ADDENDUM NO. 4

January 30, 2023

Three Rivers Community Schools – Three Rivers Middle School Additions and Renovation

This Addendum consists of Pages ADD 4-1 through ADD 4 - 3, Attached RFI Log, Substitution Request, and GMB Architecture and Engineering Addendum No. 4, dated January 26, 2023, consisting of 4 pages, Reissued Specification Sections; 08 71 00 – Door Hardware, 09 22 16 – Non-Structural Metal Framing, and 09 65 19 - Resilient Tile Flooring, New Sheet; S3.1E, and Reissued Sheets; G0.00, G1.01, G2.01, C8.01, A1.1E, A2.1E, A2.30, A5.01, A6.01, A7.03, A8.01, A8.02, M1.1D, M1.1E, M1.81, M2.1C, M2.1D, M2.1E, M3.1D, M8.01, M8.03, M8.04, M9.01, M9.02, E1.1C, E1.1D, E2.1D, E2.1E, and E7.01.

UNIT 'C' HVAC PLAN
1/8" = 1'-0"

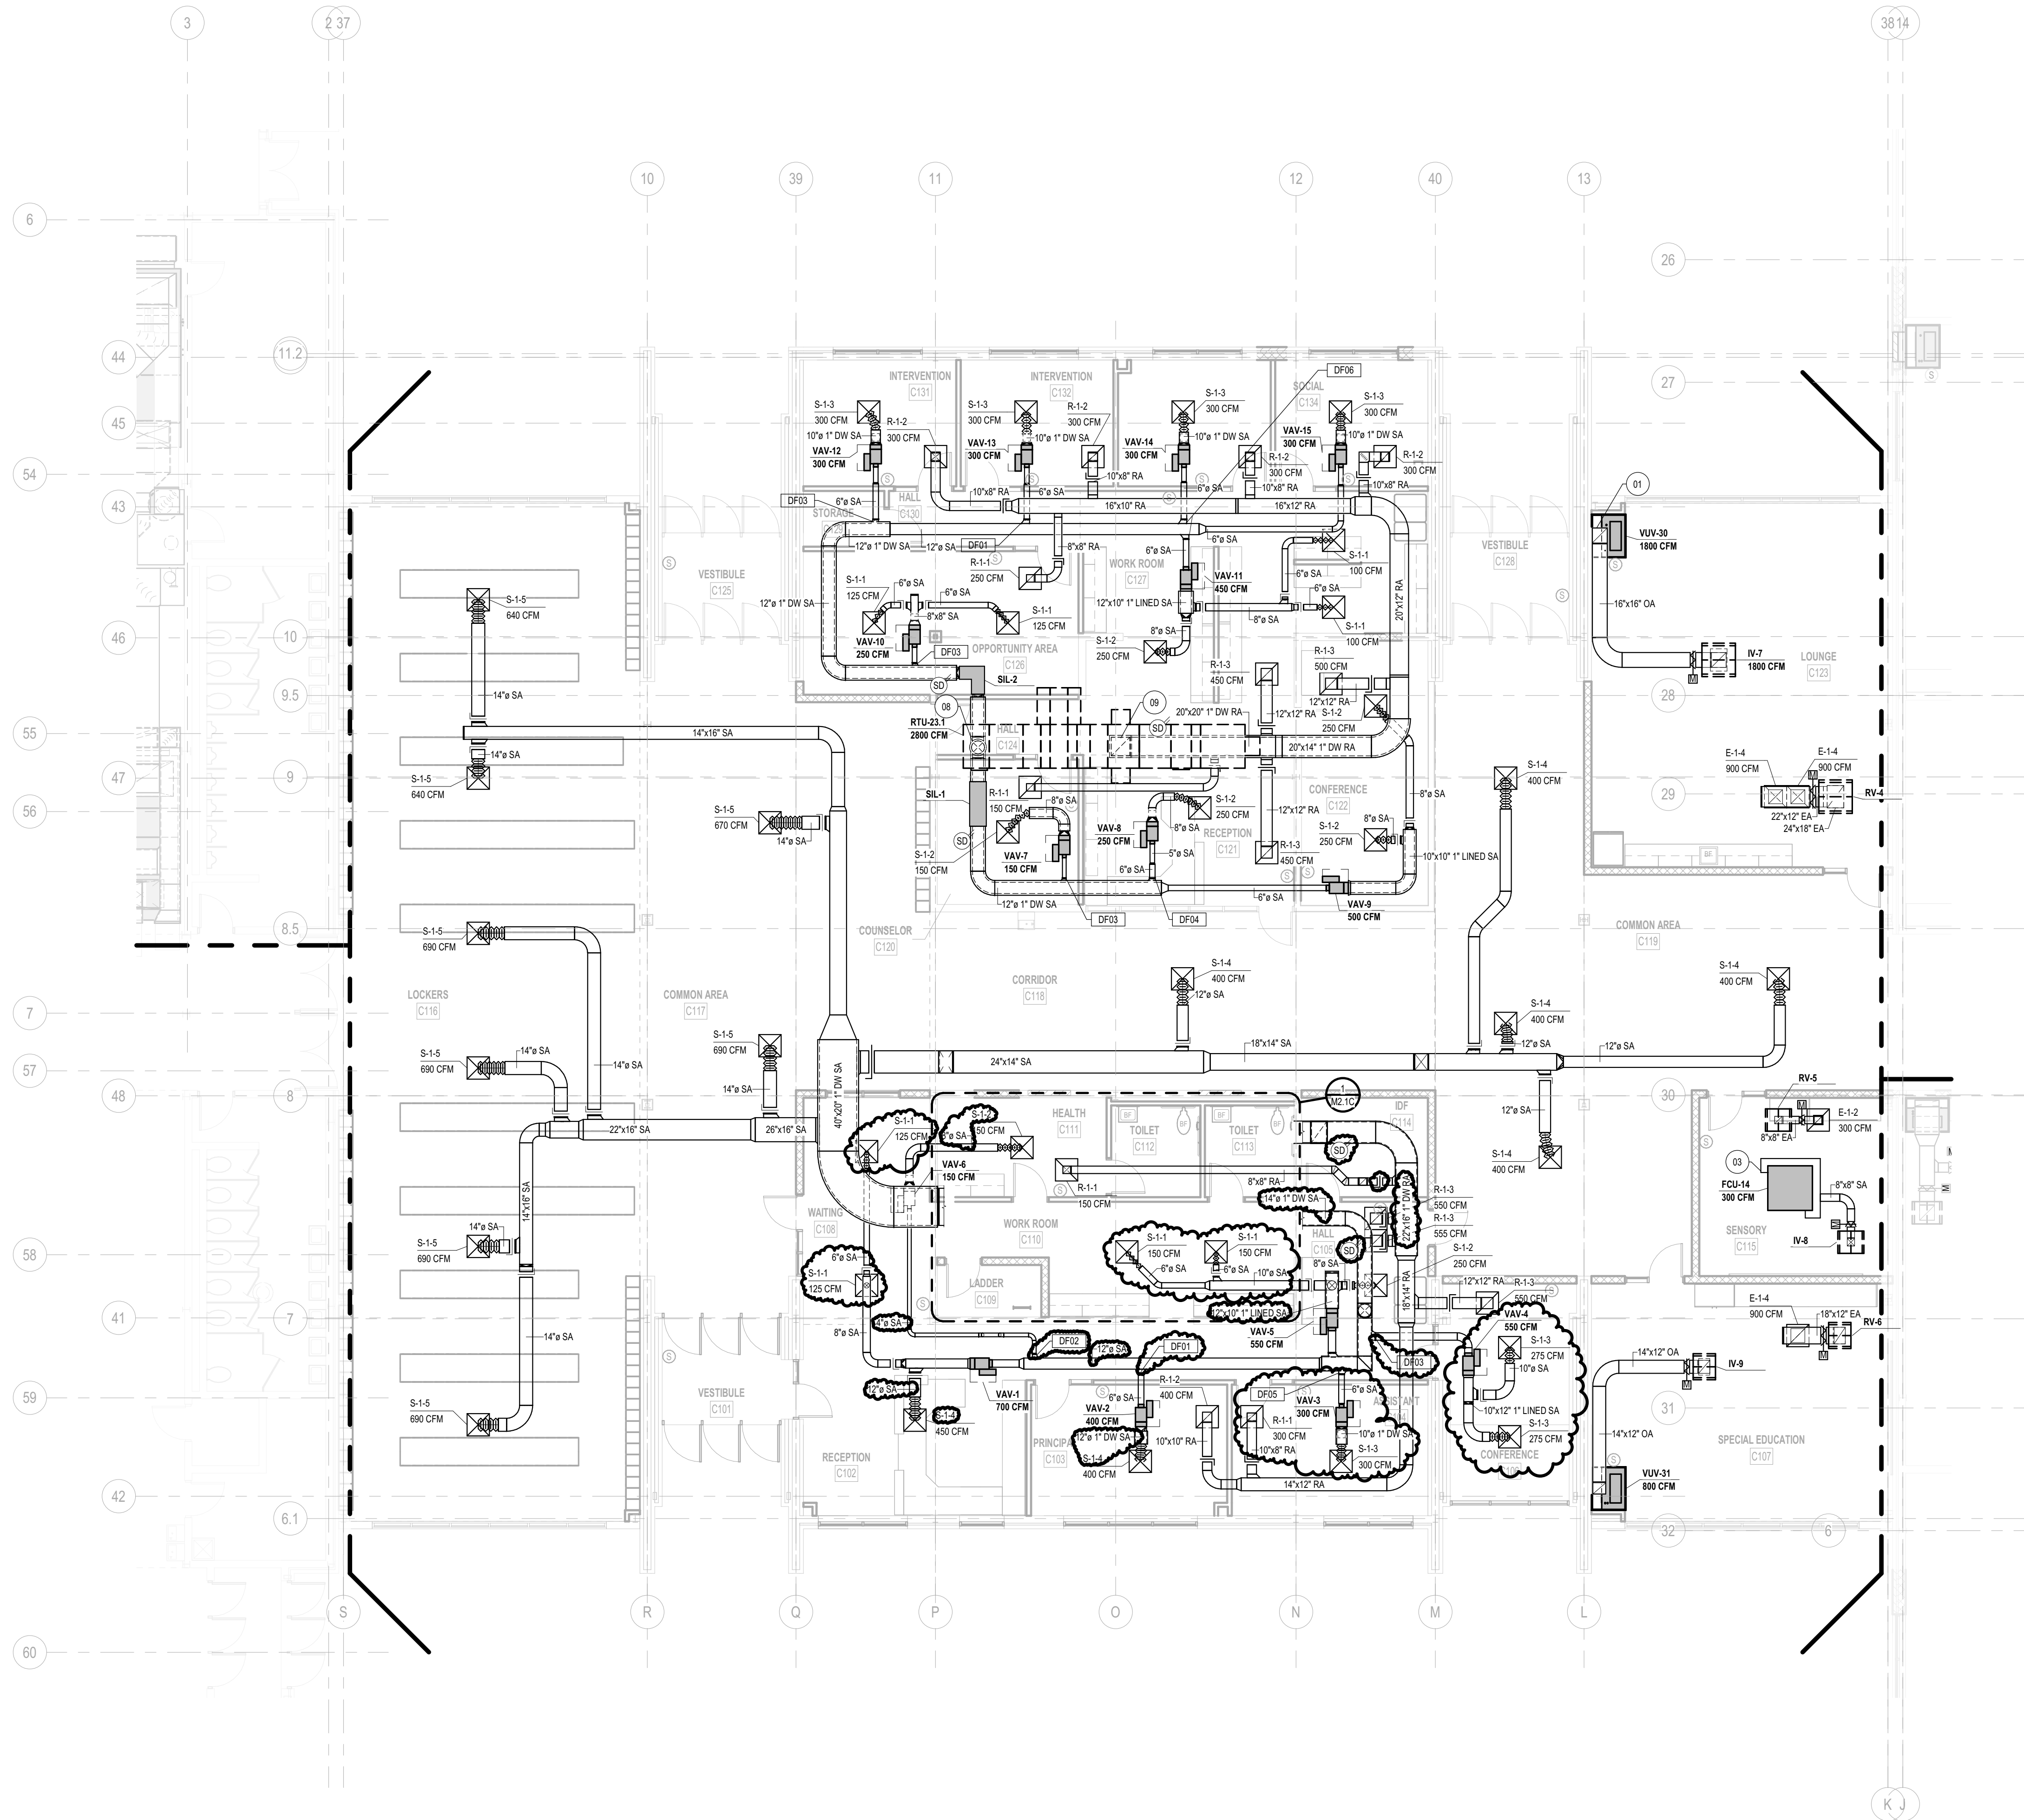
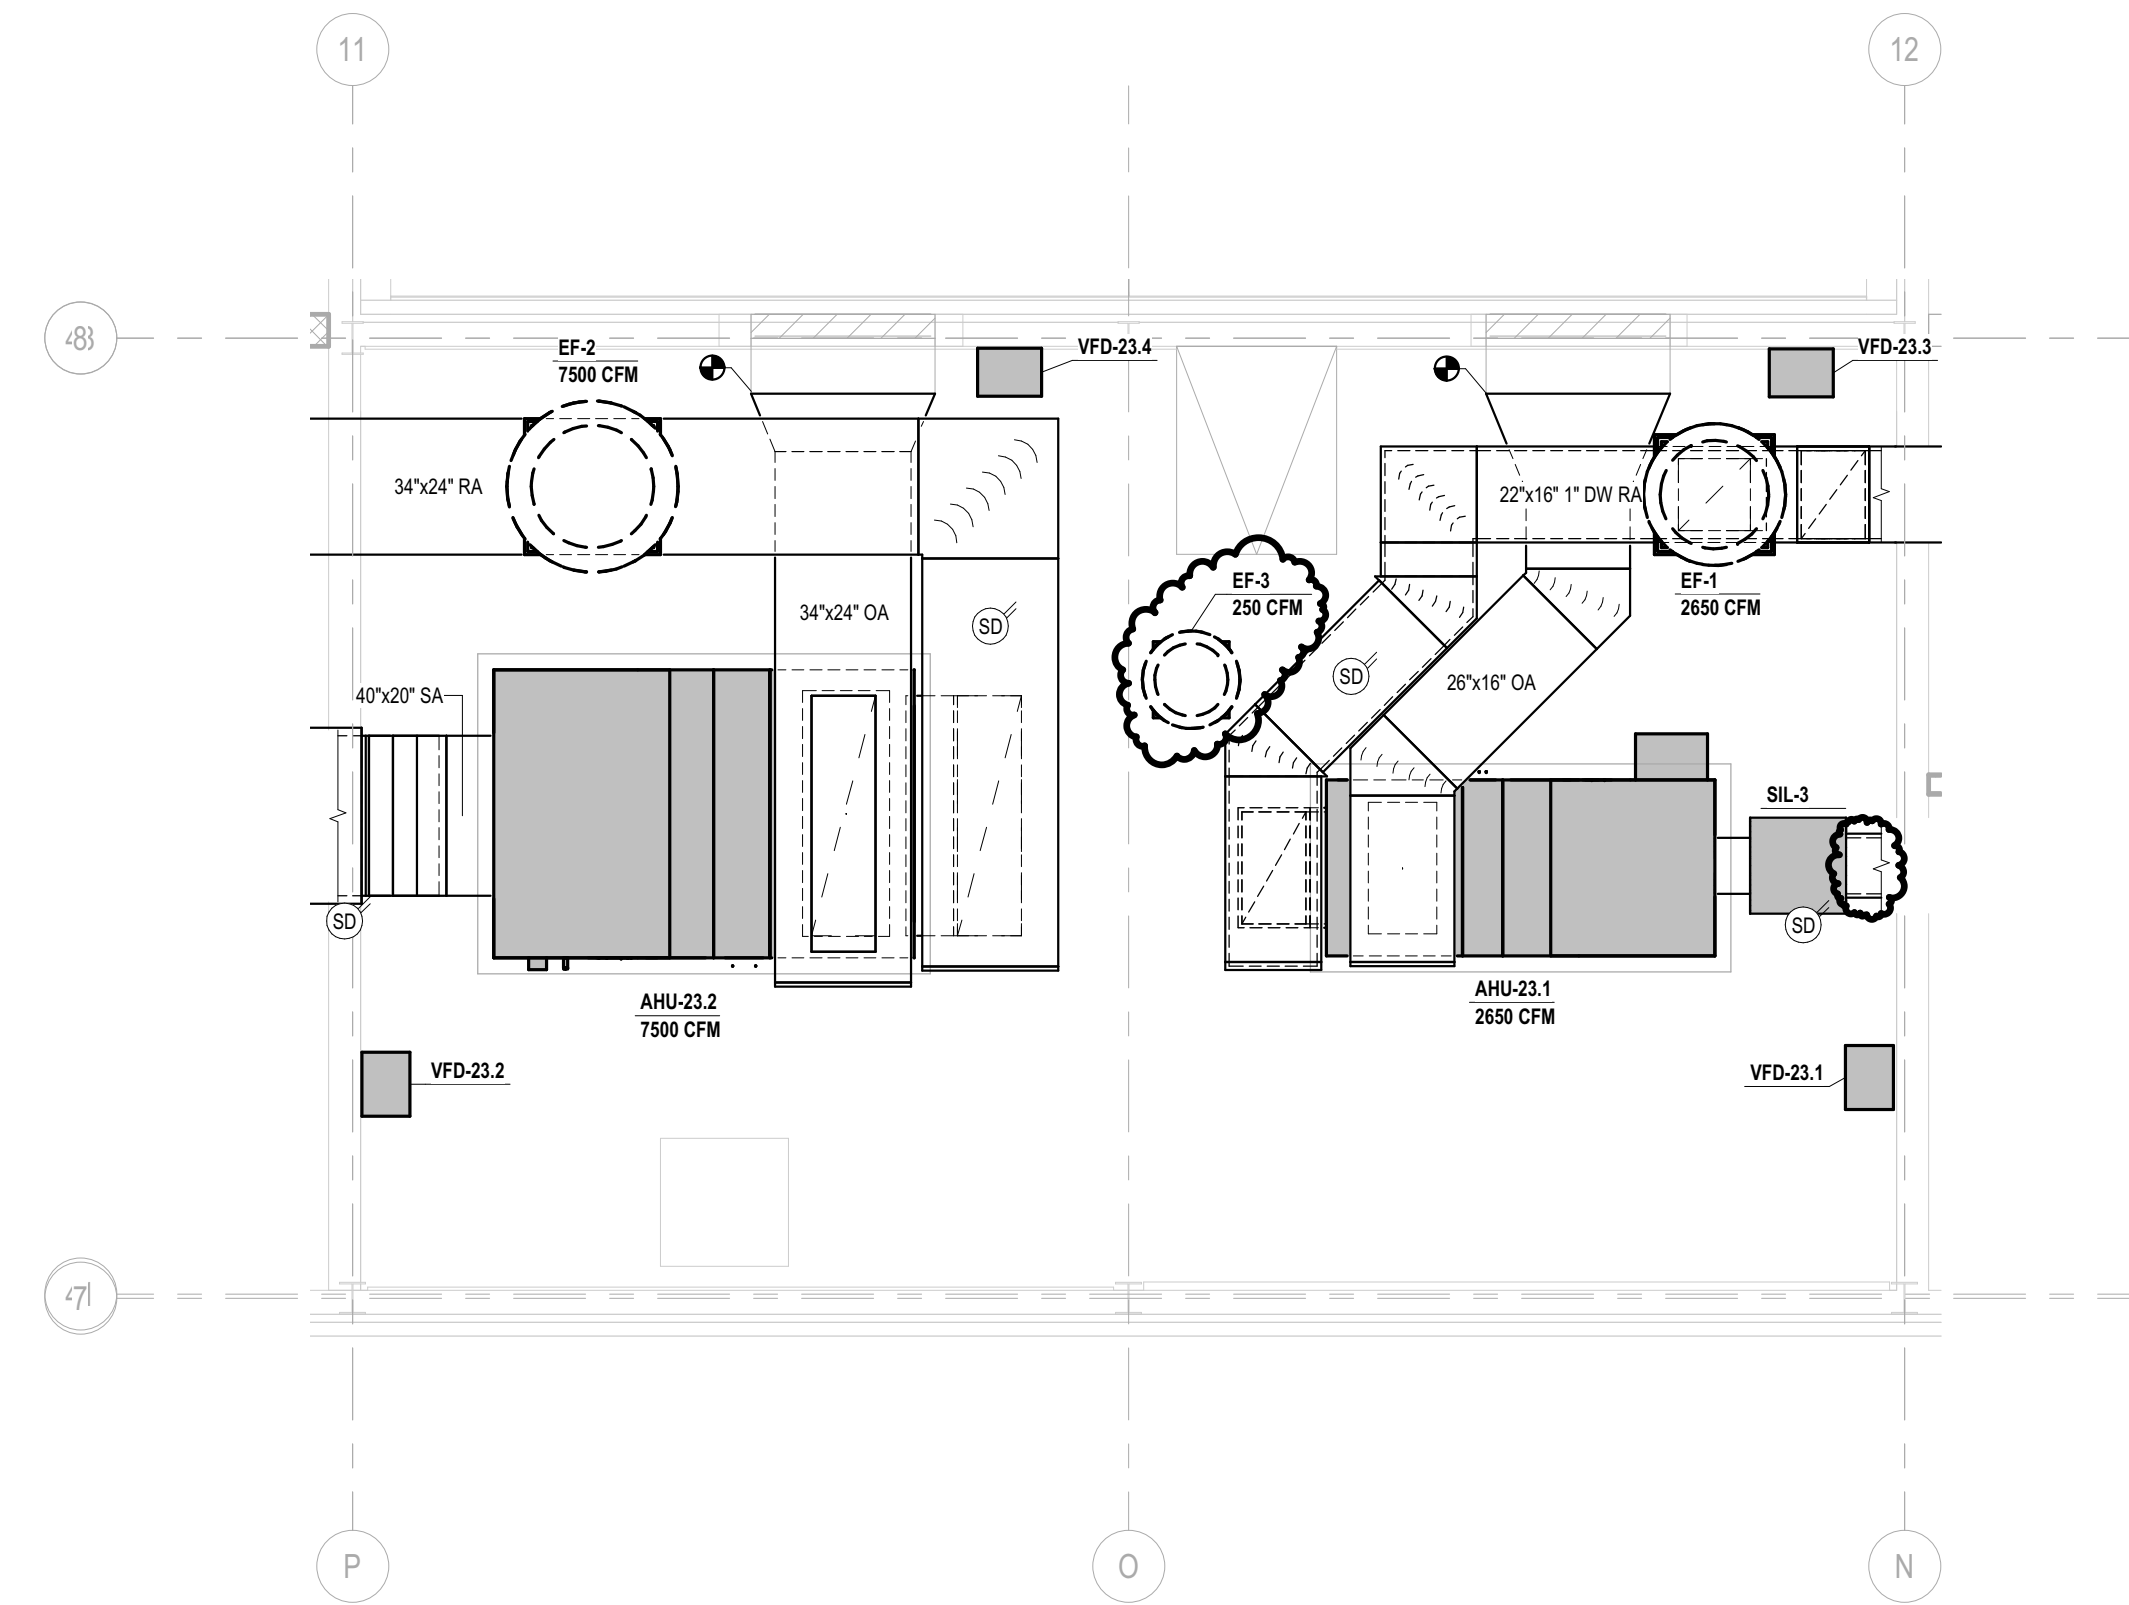
Added/revised supply, return and exhaust ductwork and added ductwork sizes.
